Docket Number:	15-AAER-06
Project Title:	Small Diameter Directional LED Lamps and General Purpose LED Lamps
TN #:	207130
Document Title:	Supplemental Staff Analysis for General Service Light-Emitting Diodes (LEDs)
Description:	N/A
Filer:	Harinder Singh
Organization:	California Energy Commission
Submitter Role:	Commission Staff
Submission Date:	12/28/2015 8:59:00 AM
Docketed Date:	12/28/2015

Subject: **Supplemental Staff Analysis for General Service Light-Emitting Diodes (LEDs)**

Figure 1: Omnidirectional Lamp Change in Tier 1

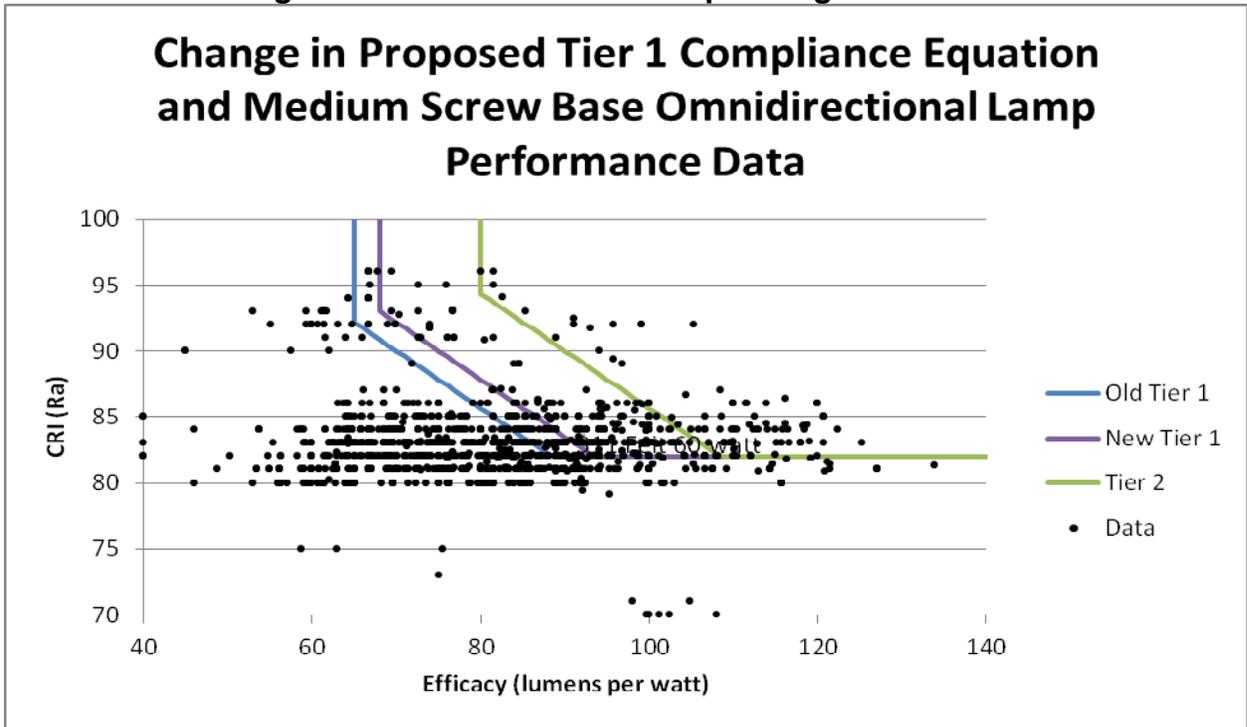
Staff proposes in 15-day language to modify the Tier 1 compliance equation as follows:

$$2.3 \times CRI + Efficiency \geq 282 \text{ and } CRI \geq 82, \text{ Efficiency} \geq 68 \text{ lpw}$$

The Tier 2 compliance equation is unchanged. The proposed effective dates are January 1, 2018 for Tier 1 and July 1, 2019 for Tier 2. The proposed changes to Tier 1 are shown in purple in the Figures 1, 2, and 3 below for omnidirectional, directional, and decorative lamps, respectively.
